## Auto-Recharging Dehydrating Breather (ARDB) Design Upgrade

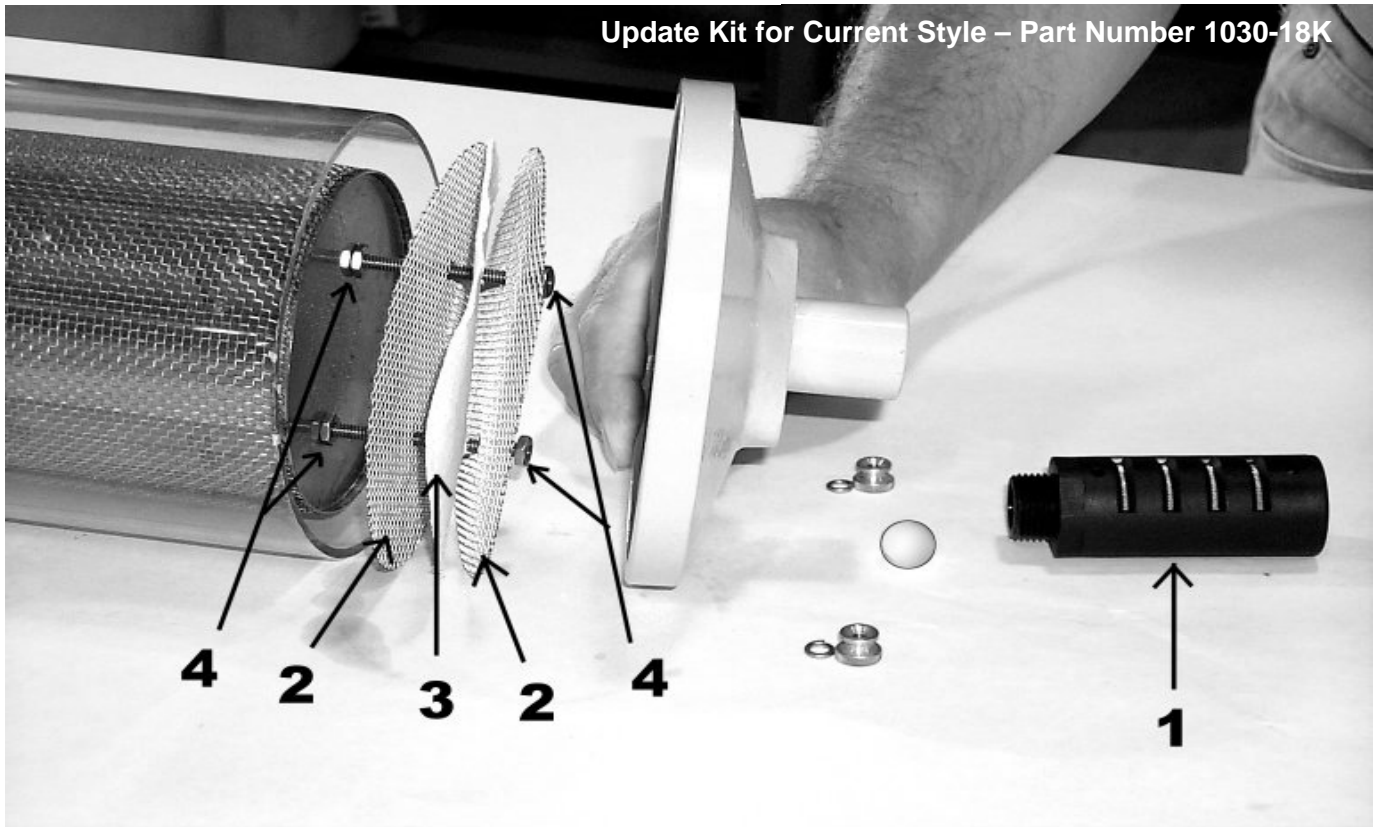
On the old ARDB designs, the commissioning instructions include the requirement to open the breather housing and remove any media from the check valve ball after adding the Silica Gel. The cleaning of the check valve ball is also required when the old design ARDB is shipped with the Silica Gel in place attached to a product, or if the Silica Gel is replaced. Failure to clean the Silica Gel dust from the check valve ball could result in the ARDB becoming inoperable.

The design upgrade places a high-grade filter element below the Silica Gel media to capture all dust from entering the check valve ball. In addition, the Breather below the check valve has been changed to allow for a more rapid release of moisture.

The filter element is not required on existing ARDBs if the Breather has already been removed and the check valve ball cleaned. We do, however, recommend the Breather upgrade.

The upgrade is easily installed by simply removing the bottom housing, adding the various components and reassembling the housing. Please refer to the illustrations on page 2.
